Access Compliance Report

Public Rights-of-Way

Intersection ID: 29718	Main Street: FALLS LAKE DR	Cross Street: RAVEN ROCK CT	Location: W
ADA ID: 51C824A2F381	Ramp Type: BlendTrans1	Initial Pass/Fail: Pass	Overall Compliance: No
			Severity Score: 15

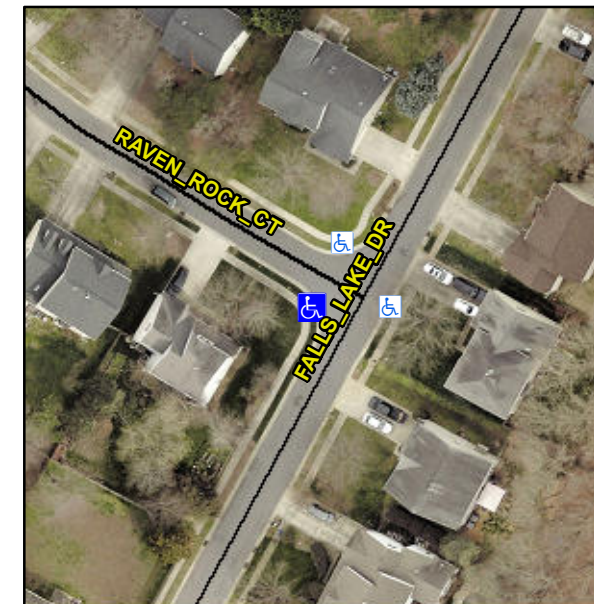
R304.2.2-Perp, R304.3.2-Para, R304.5.3, R305, R304.5.4

Compliance	Description	Data	Compliance	Description	Data
N/A	Ramp Length (in)	48.0	Yes	BlendTrans Slope (%)	3.8
Yes	Ramp Width (in)	50.0	Yes	BlendTrans XSlope (%)	0.0
N/A	Flare Type LT	Sloped	N/A	Flare Type RT	Sloped
N/A	Flare Slope LT (%)	0.4	N/A	Flare Slope RT (%)	4.6
N/A	Flare Traversable LT?	No	N/A	Flare Traversable RT?	No
Yes	Landing Length (in)	48.0	No	DWS Provided?	No
Yes	Landing Width (in)	50.0	N/A	DWS Contrast?	No
No	Landing Slope (%)	3.2	N/A	DWS Length (in)	N/A
No	Landing X Slope (%)	2.7	N/A	DWS Full Width?	No
N/A	Landing Curb? (Y/N)	No	N/A	DWS Offset (in)	N/A
N/A	Shared Landing?	No			
Yes	Gutter Ponding?	No	No	Gutter Slope (%)	8.4
Yes	Gutter Lip Ht (in)	0.0	Yes	Gutter X Slope (%)	1.9
N/A	Painted X Walk1?	No	N/A	Painted X Walk2?	No
	X Walk 1 Direction	To SE		X Walk 2 Direction	To NE
	X Walk 1 Width (in)	N/A		X Walk 2 Width (in)	N/A
	X Walk 1 Slope (%)	1.9		X Walk 2 Slope (%)	4.9
	X Walk 1 X Slope (%)	5.7		X Walk 2 X Slope (%)	2.0

N/A	Ramp inside XWalk1?	N/A	N/A	Ramp inside XWalk2?	N/A
	Road Slope (%)	2.9		Clear Space?	Yes
	Road X Slope (%)	5.6	N/A	Clear Space to XWalk (in)	N/A
Yes	Any Obstructions?	No	Yes	Storm Grate/Utility Hazard?	No
	Obstruction Type			Storm Grate/Utility Type	
			N/A		N/A
			Yes	Surface Condition? (G/P)	Good
			Yes	Curb Slope (%)	2.7

Remove & Replace Curb Ramp With Two New Directional Ramps or Equivalent. Remove & Replace Gutter.
